#### Airworthiness Directives; MD Helicopters, Inc. Model 369D, 369E, 369F, and 369FF Helicopters

**ACTION:** Notice of proposed rulemaking (NPRM).

**MD Helicopters, Inc.:** Docket No. 2001-SW-40-AD. Revises AD 2002-13-05, Amendment 39-12793.

**Figure 1 - Inspection Location**

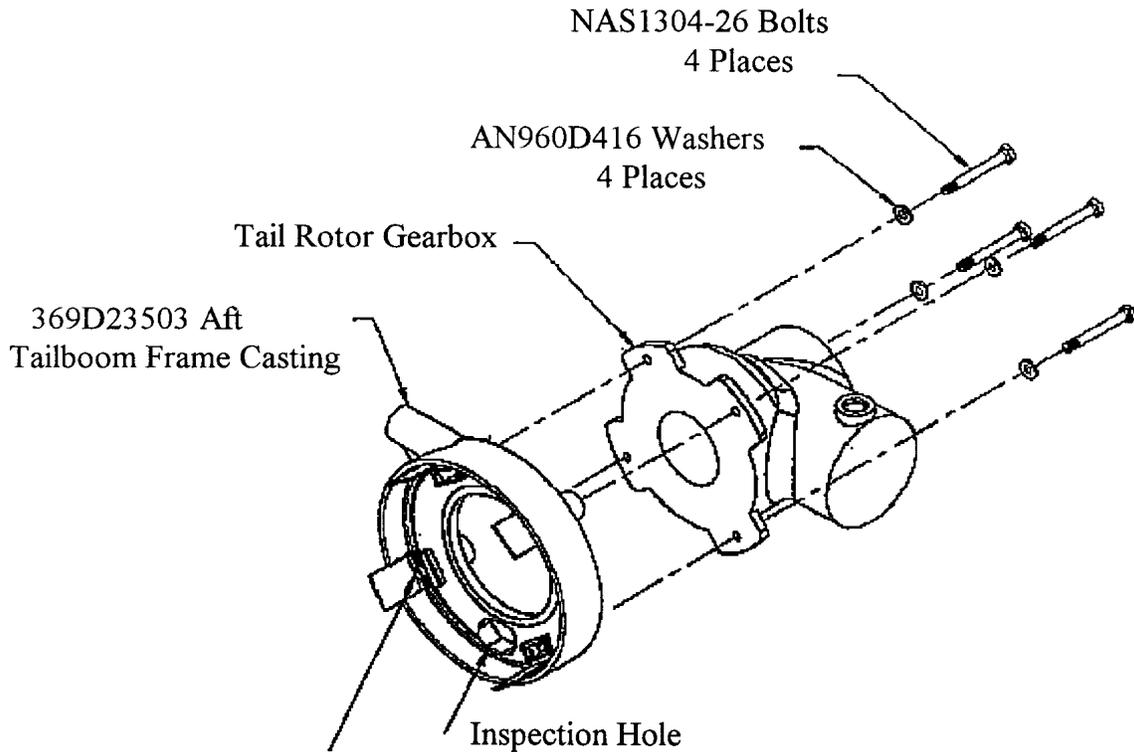
(2) Remove the tailboom control rod and determine the number of bolt threads protruding from each nutplate on the internal surface of the aft tailboom frame casting, P/N 369D23503, as shown in Figure 1 of this AD. At least one thread must protrude. If more than four threads protrude, add an additional washer, P/N AN960D416, under the bolt head. Torque the bolt to 100-110 in-lbs, and reapply a slippage mark. See Figure 1:

Inspect this area of each bolt.  
Bolt must protrude at least one thread past end of nutplate 4 places.

(b) Between 2 and 10 hours TIS after accomplishing the requirements of paragraph (a) of this AD, inspect the torque on each bolt by applying 100 in-lbs. If any bolt movement occurs, retorque the bolt to 100–110 in-lbs. Reapply a slippage mark to the bolt regardless of the outcome of the torque test. Reinspect the torque between 2 and 10 hours TIS thereafter until no bolt movement occurs.
